Gamewell FCI

Safety Bulletin

Date: February 2019 No. S19.1

Smoke response
ASD-PL3-IV, ASD-PL3R-IV, ASD-PTL3-IV detectors
operating in CLIP mode and connected to the S3 Series or E3 Series Fire Alarm Control Panels (FACP)

Example product label

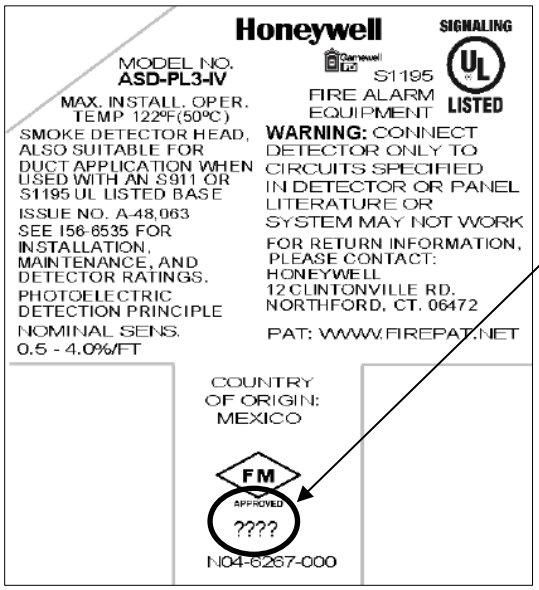
ASD-PL3-IV (Photo in Classic Ivory), ASD-PL3R-IV (Photo Remote Test in Classic Ivory), ASD-PTL3-IV (Photo Thermal in Classic Ivory) detectors manufactured from March 30, 2018 to January 14, 2019 (date codes 8034 to 9013), operating in CLIP mode and connected to the S3 Series or E3 Series Fire Alarm Control Panels are affected.

4-digit date code

Detectors used in the above specified configuration should be replaced immediately
